## BUREAU OF LAND MANAGEMENT

RE: McQuadrangle  
SRLGU #5 and  
SRLGU #24  
Section 35, T. 17 S. R.27 E.  
Eddy County, New Mexico  
Plug and Abandonment

Your sundry notices to plug and abandon the referenced wells are hereby returned. The following information is needed before approval:

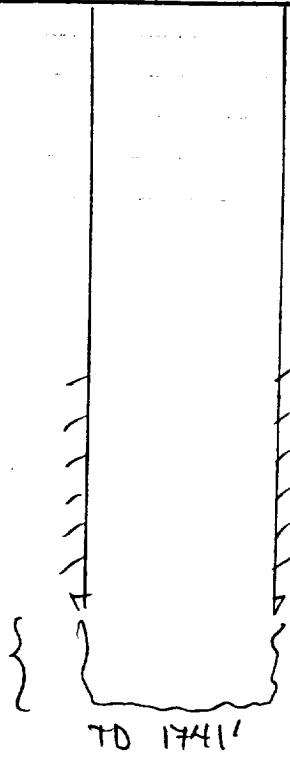
245'  
OPEN  
HOLE

7" @ 1496' w/100 ml  
(hole size unknown)  
est TOC 930'

- 1) Set a CIBP no more than 50 feet above the base of the casing and place 35' of cement on top.
- 2) The estimated top of cement in the SRLGU #5 is 732 feet. The estimated top of cement in the SRLGU #24 is 930 feet. Perforate the 7" casing and attempt to circulate cement behind the pipe. Place a 100 foot plug across the perforations.
- 3) Perforate the 7" casing at 350 feet and squeeze cement, leave a 100 foot plug.
- 4) Place a 50 foot surface plug.
